NAPOLEON SUBDIVISION

APPLICATION NUMBER 3 DATE May 21, 2009

NAPOLEON SUBDIVISION

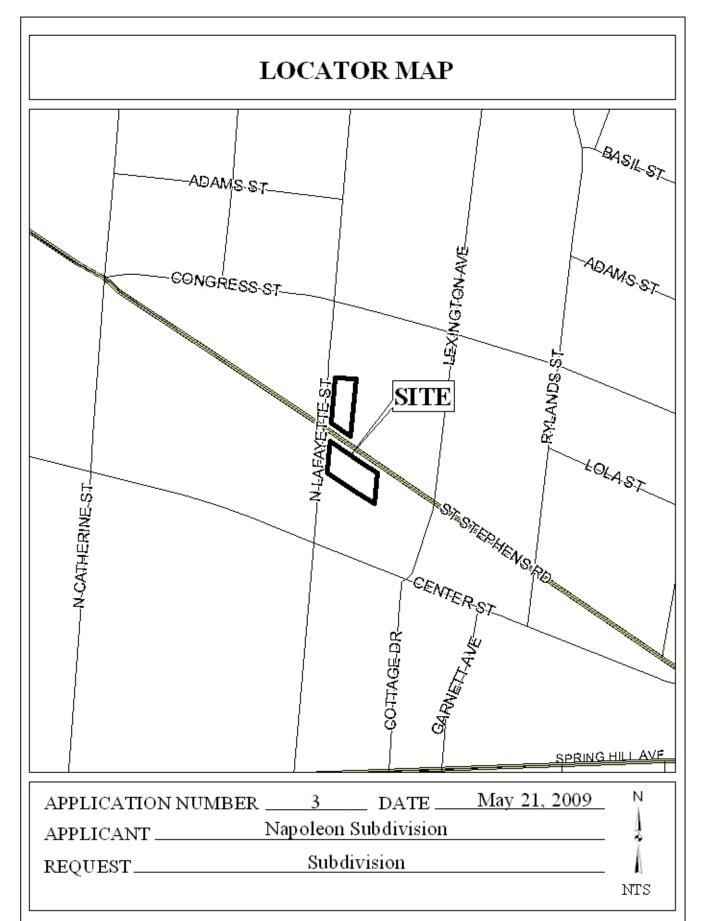
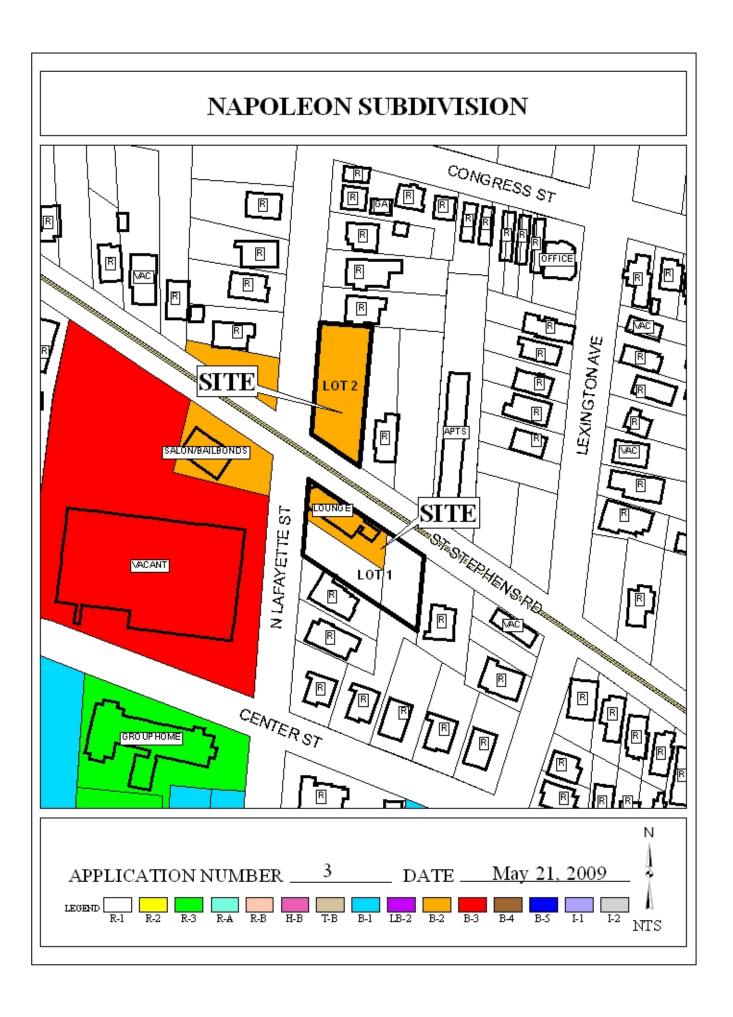
<u>Engineering Comments:</u> Must comply with all storm water and flood control ordinances. Any work performed in the right of way will require a right of way permit. Revised plat to include a minimum 25 foot radius to be dedicated to the City of Mobile at the intersection of St. Stephens Rd and Lafayette St. for both Lots. Drainage from dumpster pads cannot discharge to storm sewer; must have connection to sanitary sewer.

<u>Traffic Engineering Comments:</u> Driveway number, size, location, and design to be approved by Traffic Engineering and conform to AASHTO standards. Minimum parking aisle width is twenty-four feet. Changes should be made to accommodate this standard. There are also numerous conflict points in the parking lots that need to be remedied. Sufficient information is not provided for the driveway cuts and they appear substandard. Changes should be made to accommodate city standards.

- 1) as proposed, the plat would create a split-zoned subdivision; and
- 2) no Rezoning application accompanied this application, and none can be considered by the Commission until October, 2009, at the earliest.

This application was heldover from the May 7th meeting at the applicant's request. No revised information or plat was submitted to staff since. However, with regard to the split zoning issue which the approval of this subdivision would create, the pending Use Variance request before the Board of Zoning Adjustment would, in essence, alleviate this, if approved. Therefore, this application could be considered for Tentative Approval, subject to the approval of the Use Variance and other conditions.

- 1) the approval of a Use Variance by the Board of Zoning Adjustment prior to the recording of the final plat;
- 2) the dedication of sufficient right-of-way along Lot 1 to provide 50' right-of-way from the centerline of St. Stephens Road;

- 3) dedication of a minimum 25' radius at the intersection of St. Stephens Road and North Lafayette Street for both lots, as per the Engineering Comments;

- 4) the addition of sufficient setback for Lot 2 (75' from the centerline) along St. Stephens road to compensate for the lack of dedicated right-of-way;

- 5) placement of the 25' setback line along the North Lafayette Street frontages of both Lots 1 & 2;
- 6) placement of a note on the final plat stating that Lot 1 is denied access to St. Stephens Road and limited to one curb cut onto North Lafayette Street, with the size, design and location to be approved by Traffic Engineering and conform to AASHTO standards;

- 7) placement of a note on the final plat stating that Lot 2 is limited to the existing number of curb cuts onto North Lafayette Street and St. Stephens Road (one each), with the exact location, size and design to be approved by Traffic Engineering and conform to AASHTO standards:

- 8) revision of the plat to label each lot with its size in square feet; and
- 9) subject to the Engineering Comments: (Must comply with all storm water and flood control ordinances. Any work performed in the right of way will require a right of way permit. Revised plat to include a minimum 25 foot radius to be dedicated to the City of Mobile at the intersection of St. Stephens Rd and Lafayette St. for both Lots. Drainage from dumpster pads cannot discharge to storm sewer; must have connection to sanitary sewer).
